**Revised Phase B Site Investigation
Work Plan
Text, Tables, and Figures**

**Tronox LLC Facility
Henderson, Nevada**

AECOM, Inc.
December 2008
Document No.: 04020-023-430

Subject: Revised SAP Tables, Figures and Plates for the Phase B Source Area Investigation Work Plans for Areas I, II, III and IV, Tronox LLC Facility, Henderson, Nevada (Facility # H-000539)

SHEET NUMBER	1
FIGURE NUMBER	X

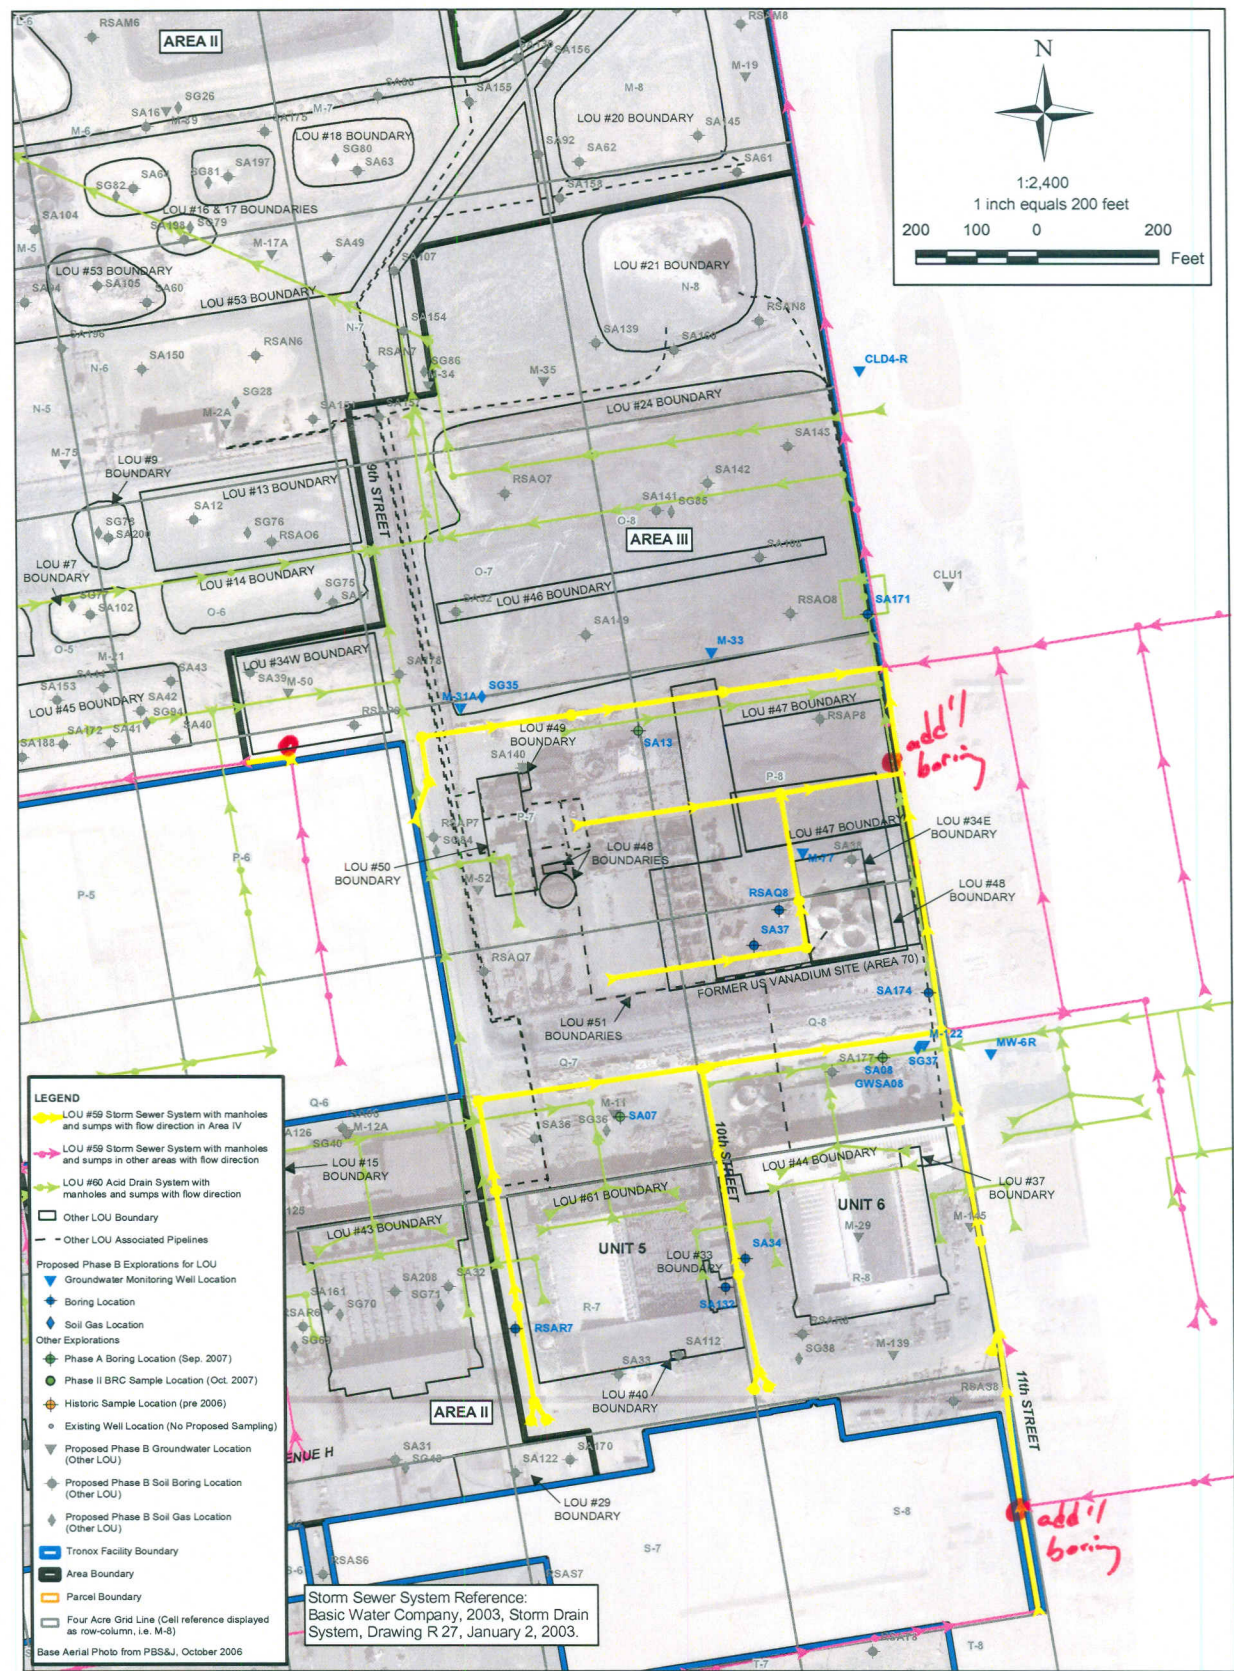
additional boring south of LOU 34W at 90° North of a clean star.
 additional boring at junction on east side of LOU 47.
 additional boring southeast portion of LOU

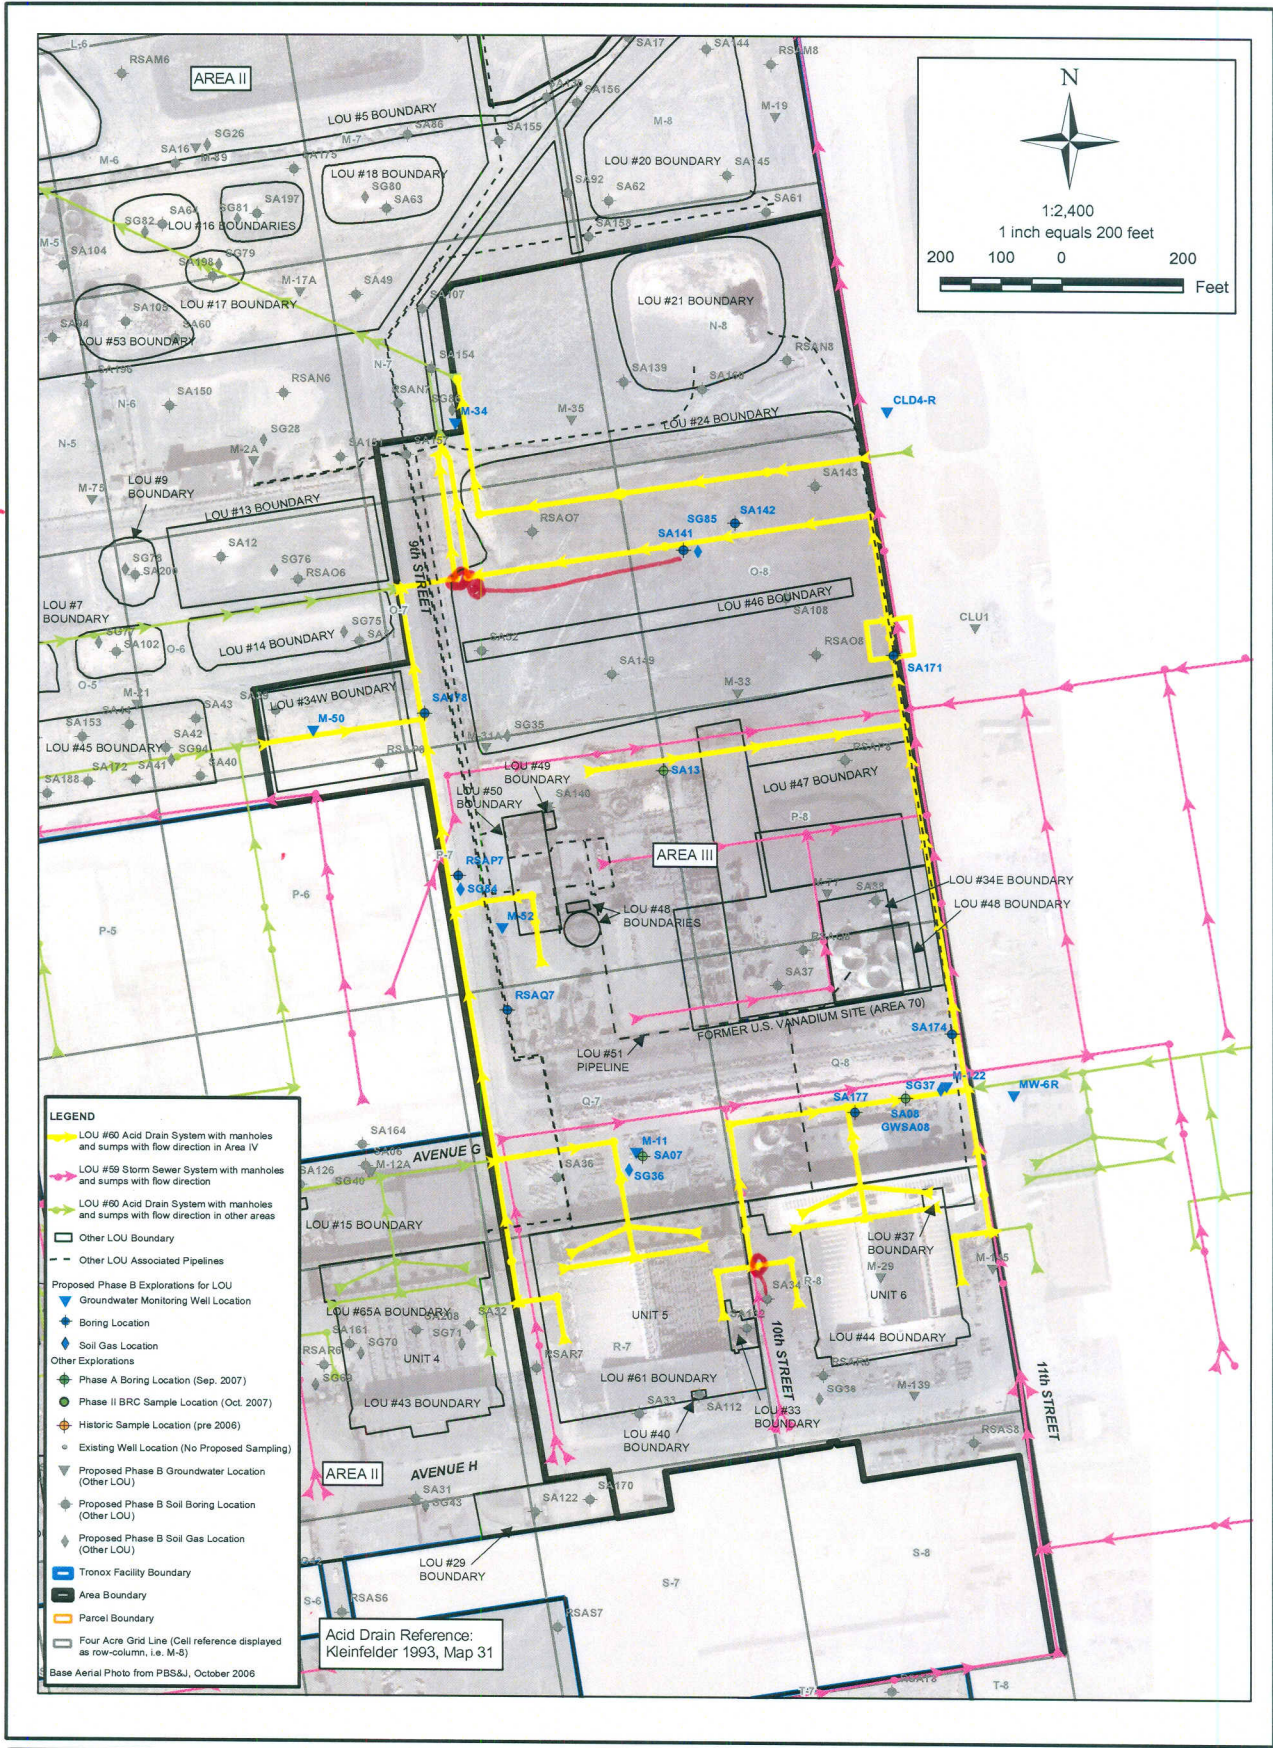
move SA141 west to the two legs of Lou60.
 move SA34 north over Lou60.
